I would like to inform you of several staff concerns regarding the draft version of IEEE P848, "Procedure for the Determination of the Ampacity Derating of Fire Protected Cables," and to ask you to bring them to the attention of Task Force 12-45 of Tests and Measurements Subcommittee No. 12 of the Insulated Conductors Committee for the IEEE Power Engineering Society. These issues arose during tests conducted by Texas Utilities Electric (TUE) and Tennessee Valley Authority for application of Thermo-Lag fire-retardant material at Comanche Peak Steam Electric Station Unit 2 and Watts Bar Nuclear Plant, respectively.

STAFF REVIEW OF CONDUIT AMPACITY DERATING EXPERIMENTS

Figure A1: Schematic for calculation of conduit heat losses
Source: Tanaka, 1994

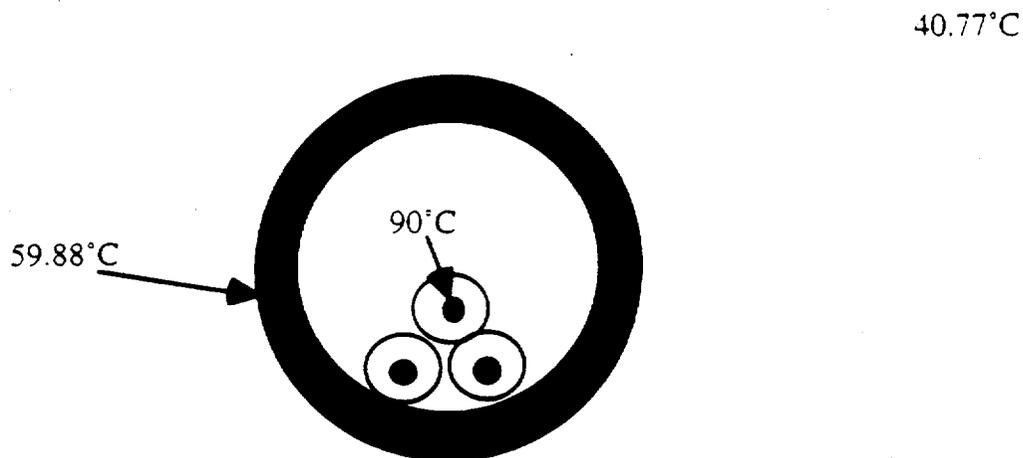
The TVA (1993) report includes information on the temperature of the outside of the conduit for the bare conduit case. For a 1-inch conduit, the outer conduit temperature was $59.88^{\circ}C$ ($139.8^{\circ}F$) when the conductor temperature was $90^{\circ}C$ ($194^{\circ}F$) and the ambient temperature was $40.77^{\circ}C$ ($105.4^{\circ}F$) (see Figure A1).

Figure A2: Protected 1-Inch Conduit Heat Flow Solution
Source: Tanaka, 1994

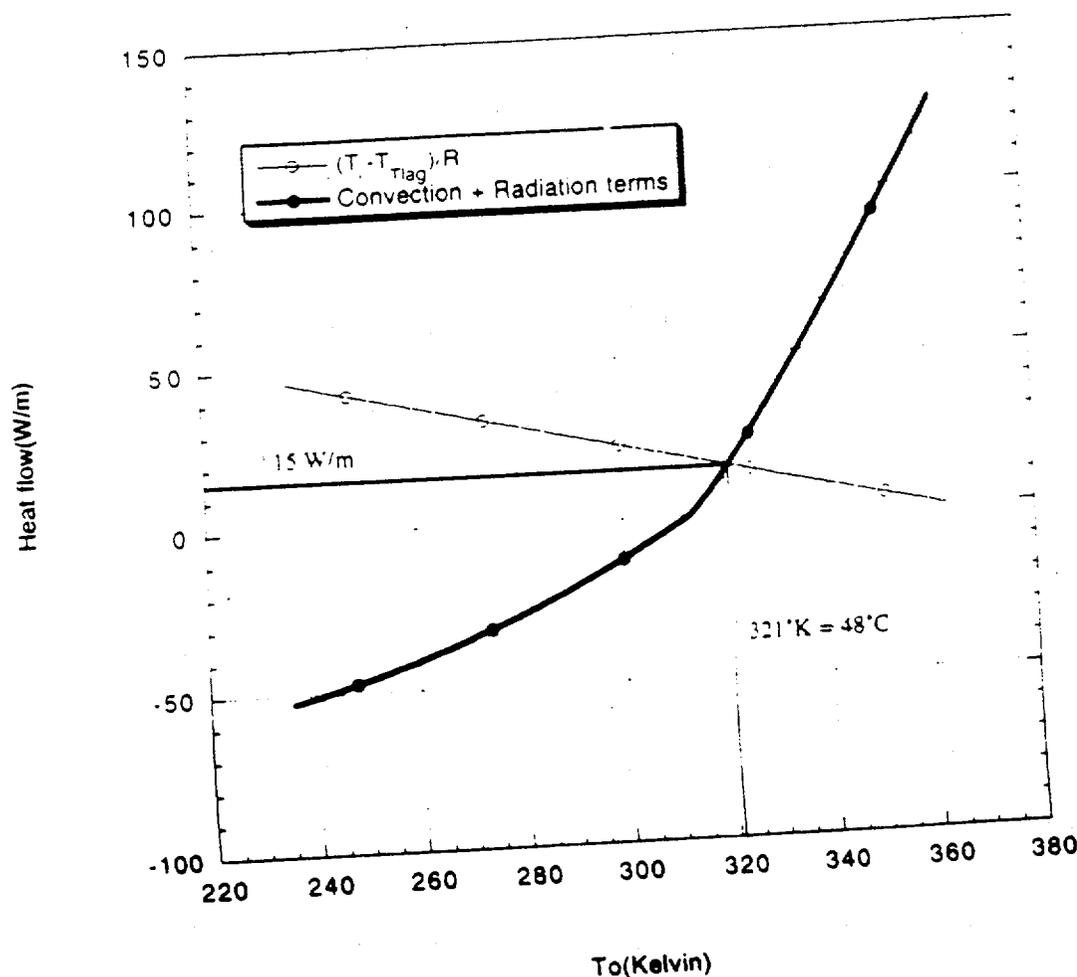
the heat flow resulting from convection and radiation. This equation is solved graphically (see Figure A2) at the point of intersection between curves.

The resulting Thermo-Lag temperature was 48°C (118.4°F) and the heat flow from the surface was 15 W/m, a larger number than the value for the baseline (i.e., bare conduit) case. The radiative contribution to this calculation is 8 W/m, while the convective contribution is only 7 W/m. For the bare conduit, however, the radiative contribution is only 2.3 W/m compared with the convective contribution of 11.3 W/m (higher convection because the conduit was hotter). This simple calculation shows that the clad conduit can have higher heat dissipation than the bare conduit, provided the emissivity and increased surface area of the fire barrier surface are high enough to offset its insulating properties.
